Seismic Walkdown Checklist (SWC)Equipment ID No. 1P70-A002B Equip. Class¹ 0Equipment Description Emergency N2 BottleLocation: Bldg. REACTOR Floor El. 130 Room, Area RL-R9

Seismic Walkdown Checklist (SWC)

Figure 4 – Bottle Cap near Rack Base (1P70-A002B)

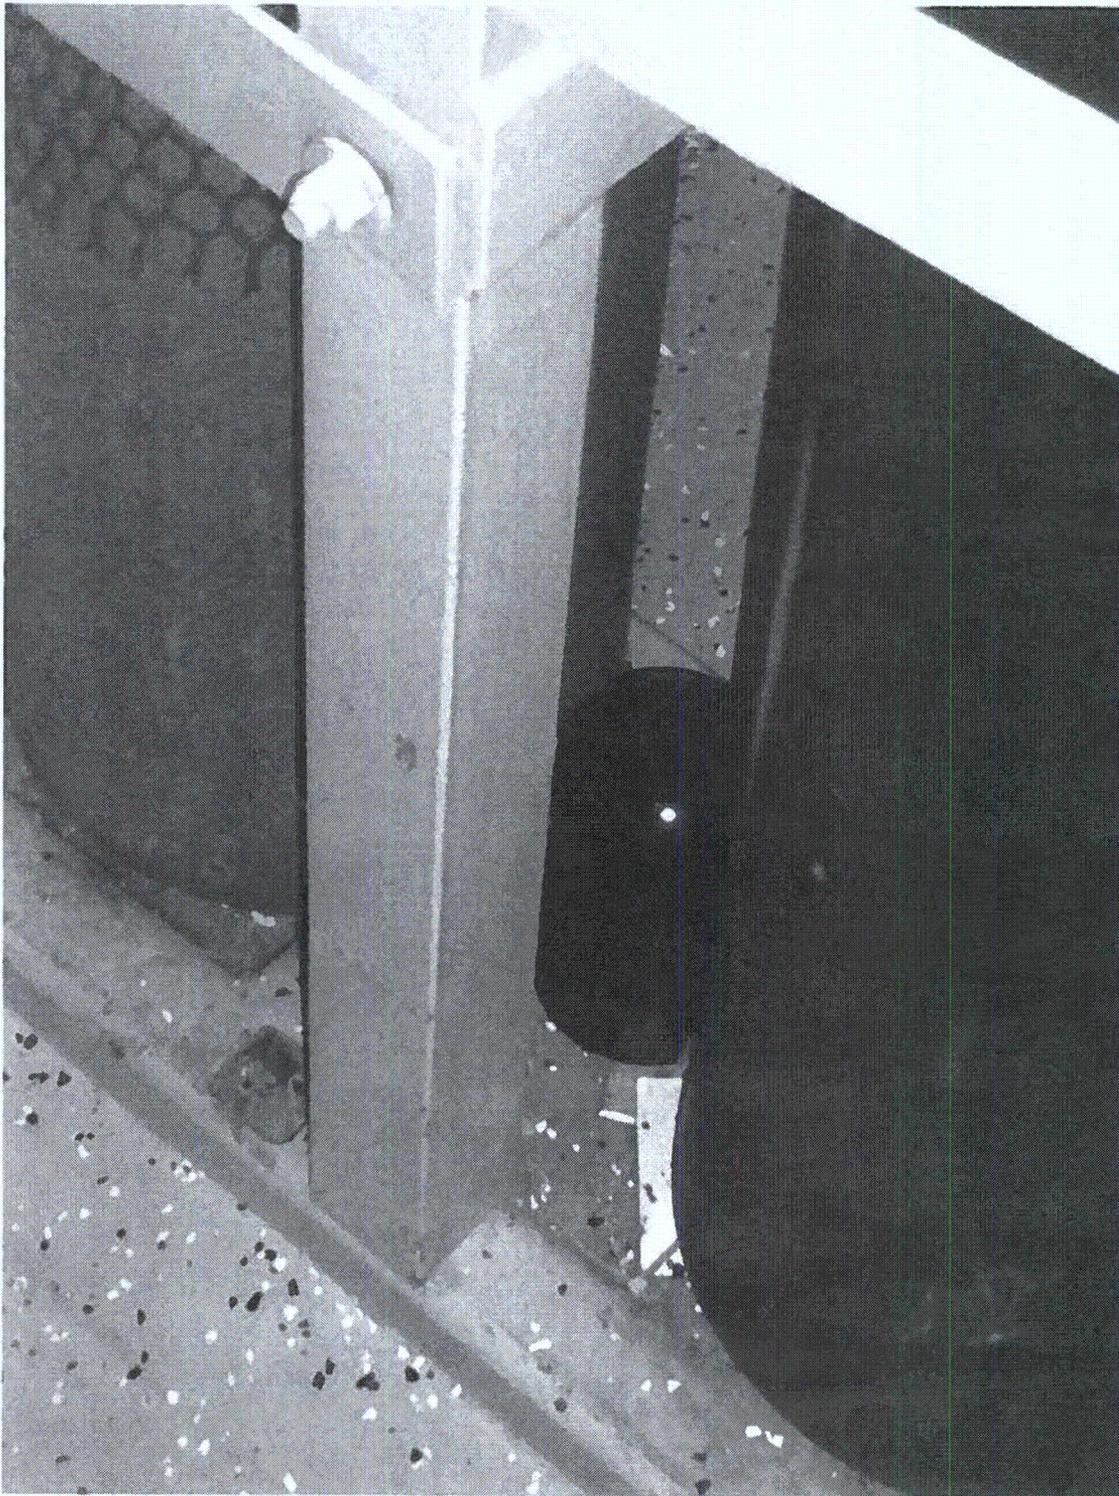
There are several housekeeping issues with Emergency N2 Bottle Rack 1P70-A002B. There does not appear to be an NPL tag affixed to the rack to aid in identifying the item (CR 516094); there is a rolled up sheet of paper with a metal tool of some sort (it appears to be a wrench) in the top left tube steel horizontal member; there is a bottle cap sitting between two of the bottles at the base of the rack; and there is a bottle cap sitting in the back of the rack near the diagonal support. In addition, there is a section of chain at the back of the rack at the same location as the bottle cap. All of these items are small and relatively light. During a seismic event, it is likely that the items will move from their existing locations, but do not have the potential to strike anything other than the bottle rack supports due to the location of the rack and its distance from any safety related SSCs. Therefore, it is judged to have no potentially adverse seismic condition.

Figure 4 Missing Support on Air Line Hard Pipe to Valve 1Z41-F009B

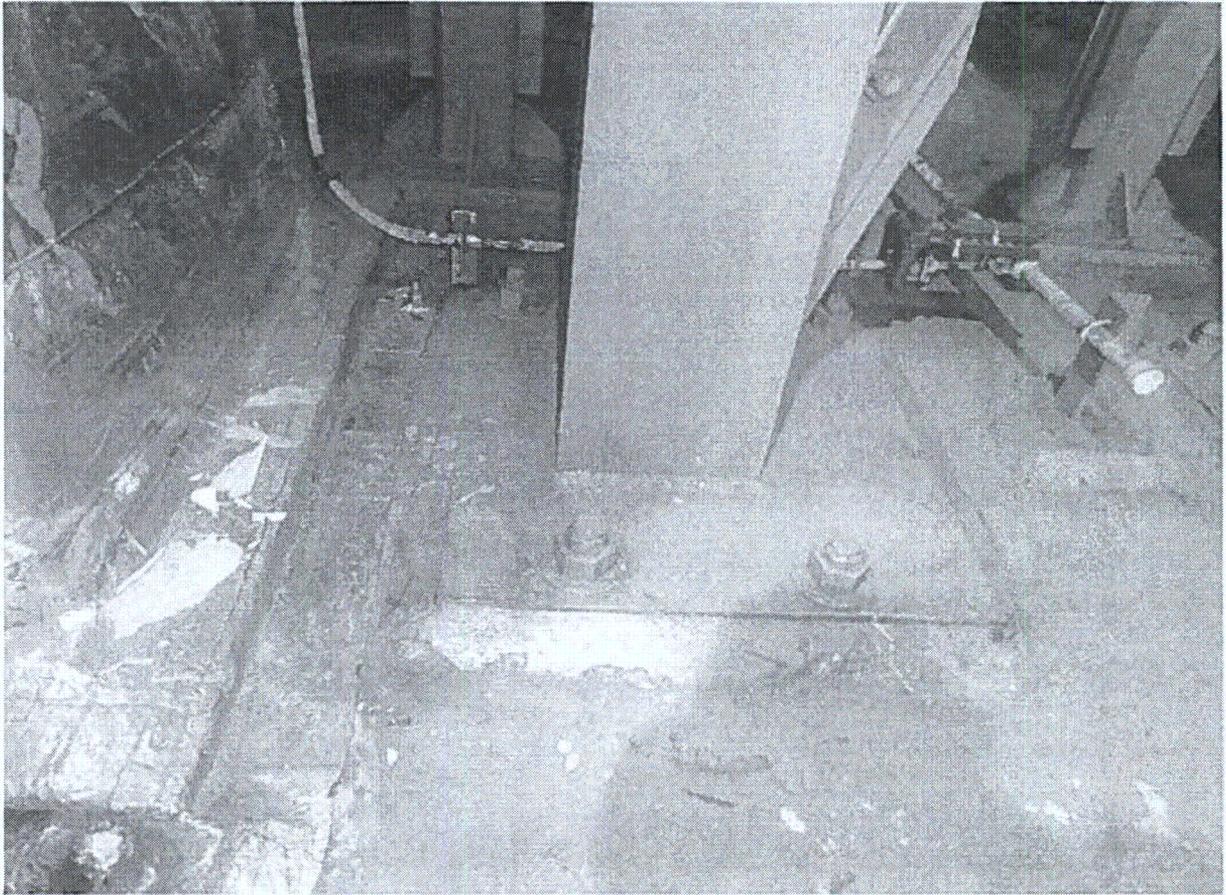
11. Have you looked for and found no other seismic conditions that could adversely affect the safety functions of the equipment? Y N U
Because the duct is insulated at the damper flange connection the flange connection bolts could not be checked for broken, missing or loose hardware. All visible surfaces were inspected and no potential adverse conditions were found. Disassembly of the insulation would be required to inspect the flange connection bolts, which are not considered to be anchorage for the component.
In addition, The seismic support of the Air Line identified as an IPEEE vulnerability described in DCR 93-055 has apparently not been completed because the Air pipe is not adequately supported for seismic loads. The end of the hard pipe needs to be attached to an existing Unistrut with a P2558 or equivalent 2 bolt pipe clamp (See Figures 4, 5 and 6 for details). CR 525292 has been written to address this condition.

Figure 3 – Attached Flex Conduit (1E21-C001A)

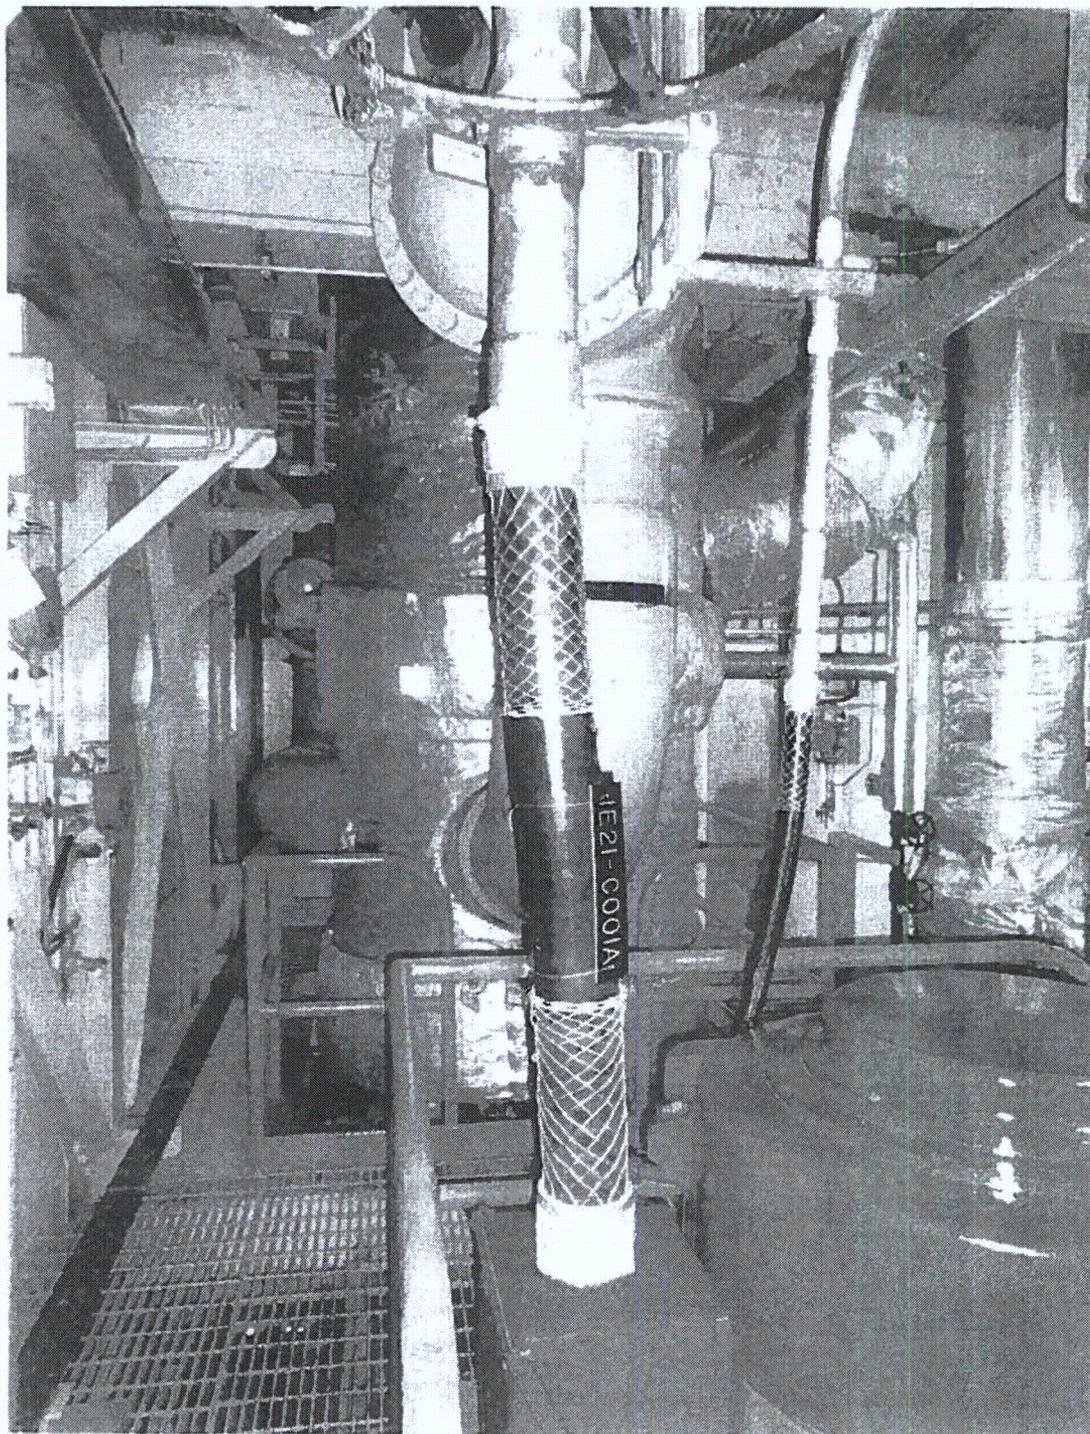
There is a flexible conduit section between the top of the pump and a rigid conduit section above the pump that is fairly tight. It is judged that the flex conduit can deflect 1" without putting significant stress on the conduit. SWE's judge that the pump will move less than 0.5" during a seismic event due to the elevation and rigidity of the equipment. Calculation SCNH-91-069 Rev. 0 for the adjacent RHR pump of the same type gives a maximum pump deflection of less than 0.2" at the top of the pump. Therefore, it is judged that the line has adequate flexibility for the pump seismic deflections.

Figure 3 Conduit Tied between Battery Chargers on the same wall

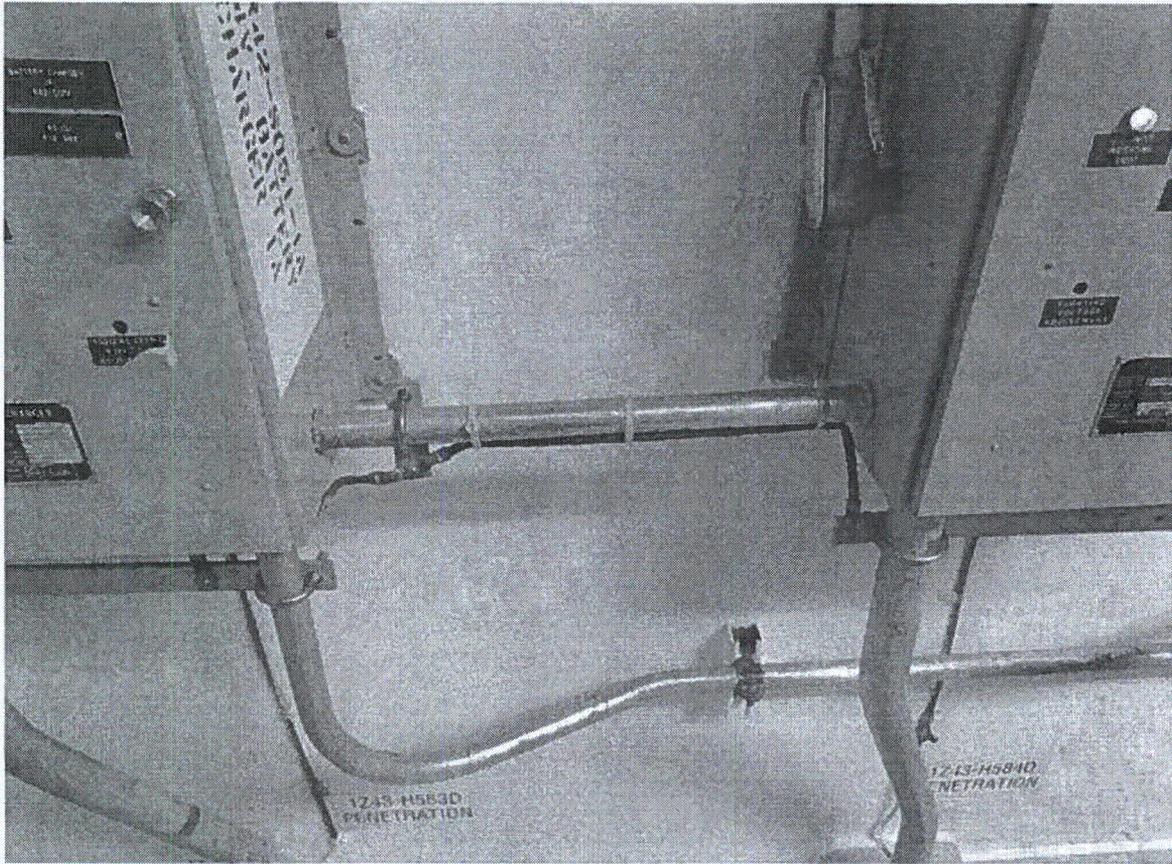
The conduit interconnecting the chargers shown in Figure 3 is not a seismic concern because the chargers are anchored to the same wall so there will be no seismic differential movements between the two Battery Chargers.

Figure 3 – Abandoned Fall Protection Strap (1P52-A001)

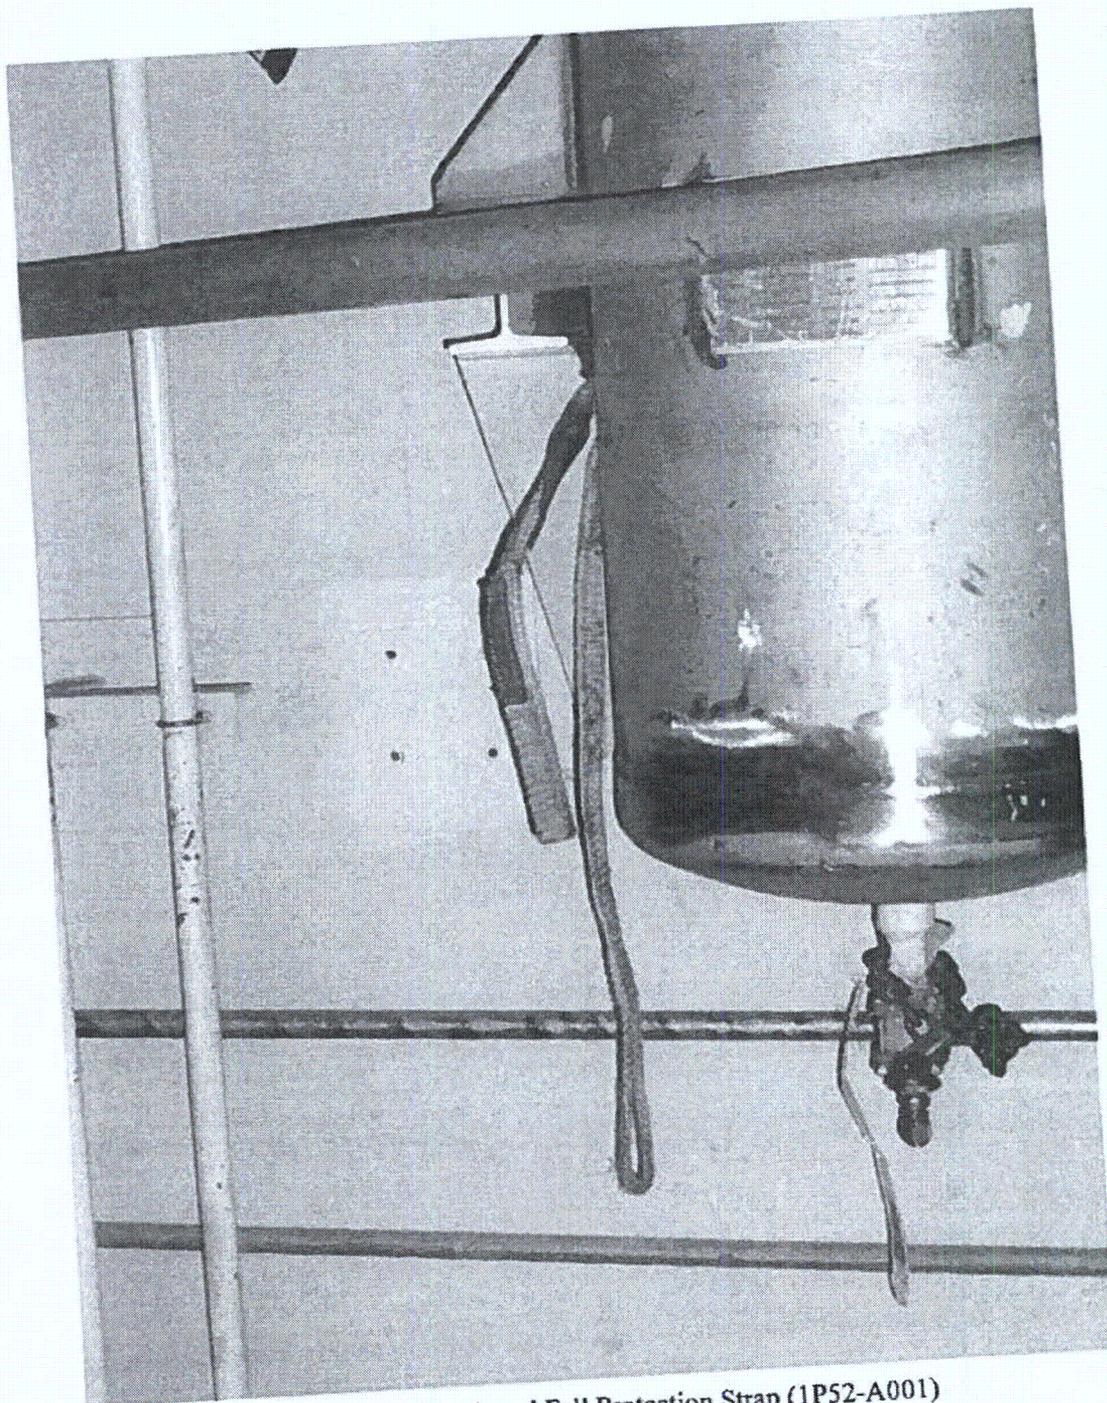
11. Have you looked for and found no other seismic conditions that could adversely affect the safety functions of the equipment? Y N U
- There is a fall protection strap left on the ESS Air ACC (CR 519465). The strap is wedged between the component and the support steel and is not attached to any other fall protection equipment. It appears that the strap could not be removed from the support and was abandoned. The strap is very light and is not near any sensitive parts of the component, so it is judged that the strap does not have the ability to create a potentially adverse seismic condition.*
